COVER SHEET FOR PRELIMINARY/FINAL SUBDIVISION AND LAND DEVELOPMENT PLAN SM&B ENTERPRISE LLC FAIRVIEW ROAD MOUNT JOY TOWNSHIP LANCASTER COUNTY, PENNSYLVANIA DRAWING #: CG-4082 SHEET #: 1 OF 31		PROJECT NO.: 5183-20 DATE: JUNE 10, 2026 DRAWN BY: BRC CHECKED BY: BRC SCALE: 1"=100'
---	--	--

Re: Final Subdivision and Land Development Plan for SM&B Enterprises, LLC
Our File No. 10221-1

Re: SM&B Enterprises LLC
Final Subdivision and Land Development Plan
Township Permit No. 26-04-FSDP
LCEC Project No: 25-241

DRAWING #: CG-4082
SHEET #: 20 OF 31

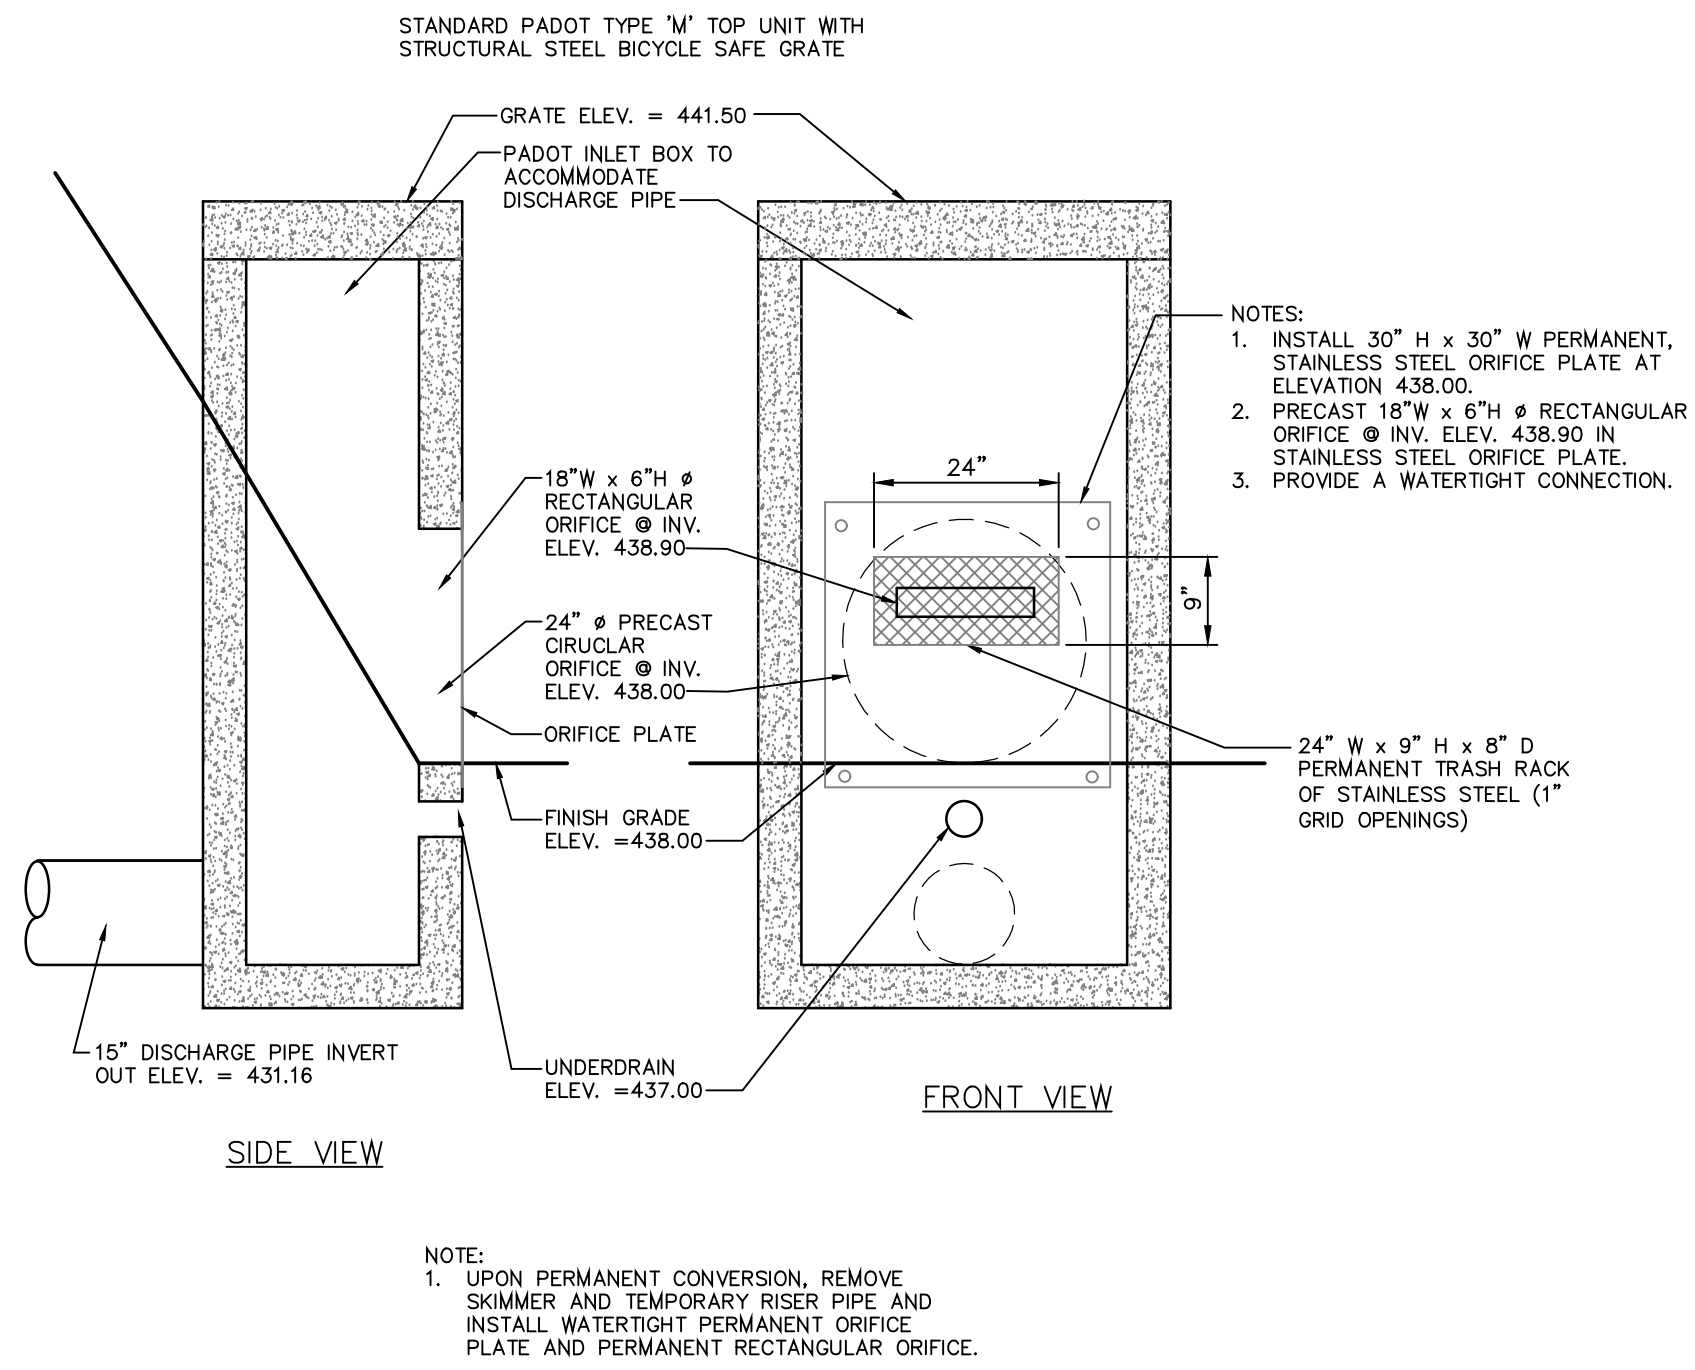
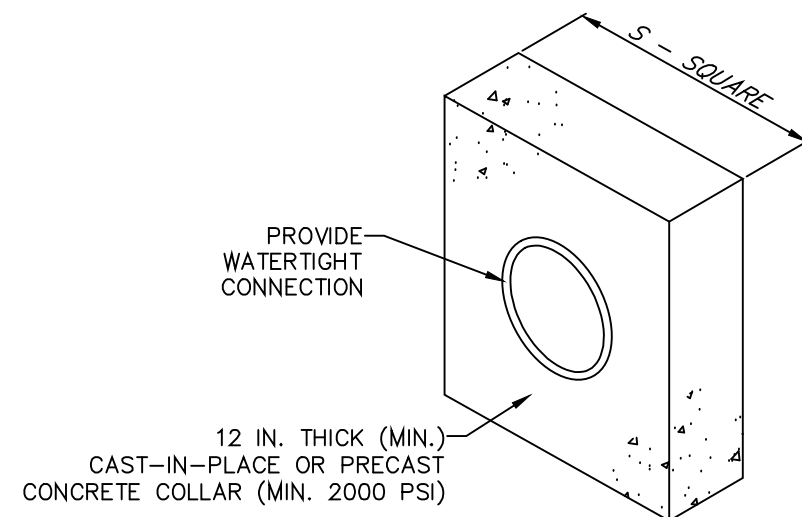
There will have to be a Storm Water Management Agreement and Declaration of Easement for the Plan. The Plan proposes a substantial infiltration basin on Lot 1 between Fairview Road and the proposed street. There do not appear to be any storm water management facilities on the two smaller lots although there is some grading on 3 at its southeast corner. I assume that the owner of Lot 1 will be responsible to maintain the storm water management facilities. The Storm Water Management Agreement must contain all of the operations and maintenance requirements on Sheet 20 of the Plan.
